PERRY NUCLEAR POWER PLANT DEVIATION ANALYSIS REPORT

ITEM Ruskin Fire Dampers	LOCATION Perry Nuclear Power Plant	QUANTITY 85
ORIGINATOR <i>MAB</i> M. A. Brown <i>RLV</i>	ORGANIZATION Construction Quality Engineering	DATE 8/8/80
RESPONSIBLE ORGANIZATION Ruskin Manufacturing Company	SPECIFICATION SP-49/91	REFERENCE DOCUMENTS See Attached

Cleveland Electric Illuminating Co.
Perry Nuclear Power Plant
HVAC Contract No. P-1527-V
Modification of Vertical Spring
Closure, N1BD23 Fire Dampers

Subject: Ruskin's Vertical Spring Close IBD Fire Dampers

OWN. BY: T. LASHER DATE 1-14-80	CKD. BY: TA DATE 1-17-80	APP'V'D. BY: RVB DATE 1-14-80	CHANGE LETTER	REVISION DESCRIPTION	OWN. BY	APP'V'D. BY	DATE
RUSKIN MFG. CO. P.O. Box 129 Grandview, Mo. 64030				SCALE	ISSUE		
TITLE				DWG. NO.			
VERT. N18023 SPRING BRACKET MODIFICATION				5398		1

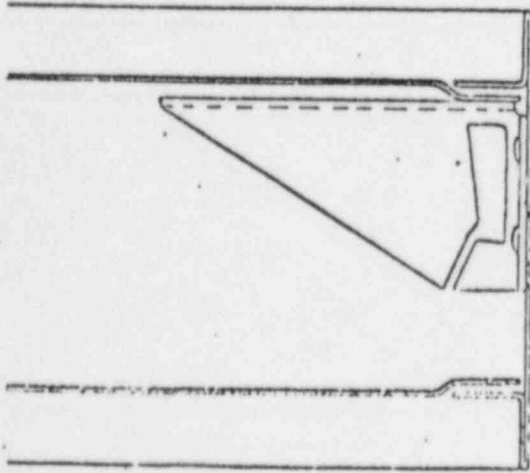
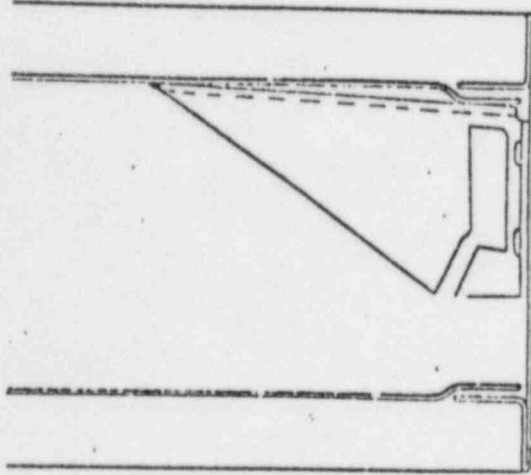
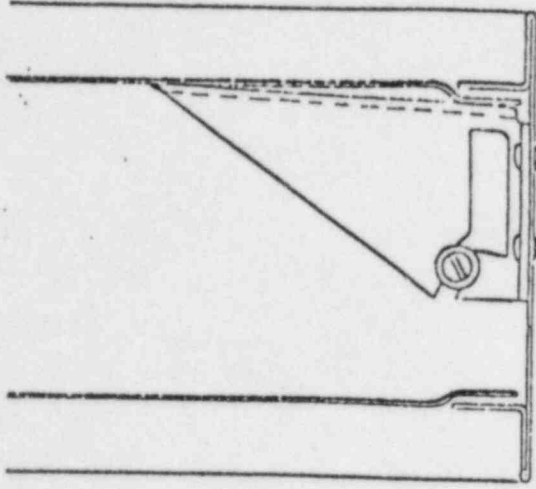
Vertical IBD type Fire Dampers with spring closure built by Ruskin after June 1979, have spring brackets installed with two rivets through the bottom of the frame and a tackweld holding the top of the bracket to the blade guide. Previous to this date, brackets had not been tackwelded to the blade guide. Addition of the tackweld came about after noting that repeated closings of the blade package during air test at our laboratory caused some bending in the brackets. Fastening of the bracket to the blade guide was to provide extra support for the bracket; however, it also alters the shape of the spring holding slot. This was discovered recently when we recieved a report from one job site of some springs coming out of brackets while the damper were being cycled. The engineering firm for this job has advised Ruskin that this problem is reportable under 10CFR part 21. Ruskin has reported it accordingly.

ORIGINAL INSTALLATION
(VERTICAL FIRE DAMPERS
WITH SPRING CLOSURE)

TOP EDGE OF BRACKET
TACKWELDED TO PROVIDE
EXTRA SUPPORT FOR
BRACKET & RESULTING
ALTERATION OF SPRING
SLOT

Ruskin, with the help and cooperation of the engineering firm for the project where this problem was discovered, has come up with a simple method for eliminating this problem. It consists of placing a #6 screw using a washer, star lockwasher and hex nut through the narrow portion of the spring slot (see drawing 5398 attached). This fix was successfully tested on a "worst case" damper at our laboratory, after duplicating the spring slipping problem.

PROPOSED FIX- #6 SCREW,
WASHER, STAR LOCKWASHER
& HEX NUT TO KEEP
SPRING FROM SLIPPING
OUT OF SLOT

OWN BY: T. LARSEN	DESIGNED BY: T.A.	SCALE: 3-27-80	DATE: 3-27-80	APPROVED BY: RUB	DATE: 4-2-80	REVISION DESCRIPTION: RUSKIN Mfg. Co. P.O. Box 128 Grandview, Mo. 64030	OWN. NO. 2015	DATE 4-6-84
TITLE: VERTICAL FIRE DAMPER BRACKET INDICATIONS						ISSUE 1

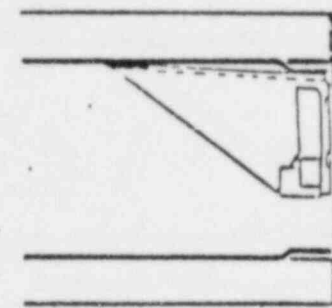
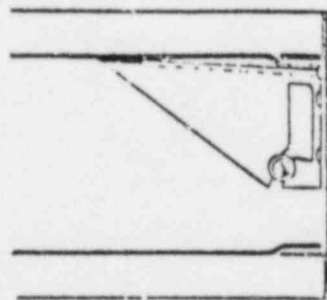
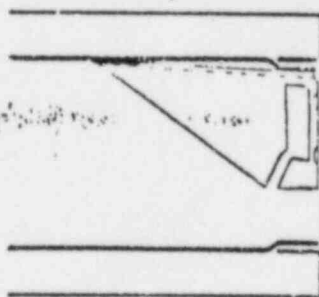
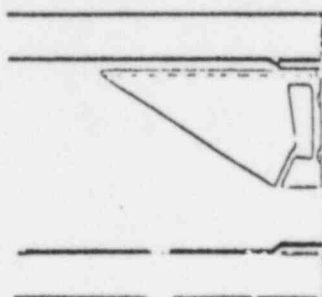
In our notice to you dated January 21, 1980, we addressed a problem relating to Ruskin's vertical, spring close, NIBD23 Fire Dampers and a fix or correction was suggested which consisted of fastening a #6 screw in the narrow portion of the slot in the spring brackets.

Although it appears that this method should have eliminated the problem, an engineering firm has indicated to us that some of the screws worked loose during shipment. This raises the possibility that the use of screws as a fix is questionable. We therefore request that you stop any activity relative to the installation of this fix.

ORIGINAL FIX USING
#6 SCREW, WASHER, NUT
LOCKWASHER & NUT

TOP EDGE OF BRACKET
TACKWELDED TO PROVIDE
EXTRA SUPPORT FOR
BRACKET & RESULTING
ALTERATION OF SPRING
SLOT

Ruskin has now developed an alternate fix consisting of a small metal clamp which attaches to the spring bracket and provides a positive stop for the spring (see drawing 5564).

SPRING BRACKET
BRACKET CLAMP
INSTALLATION DETAIL

INSTALLATION OF
PROPOSED BRACKET
CLAMP (SEE DETAIL
PAGE ALSO)
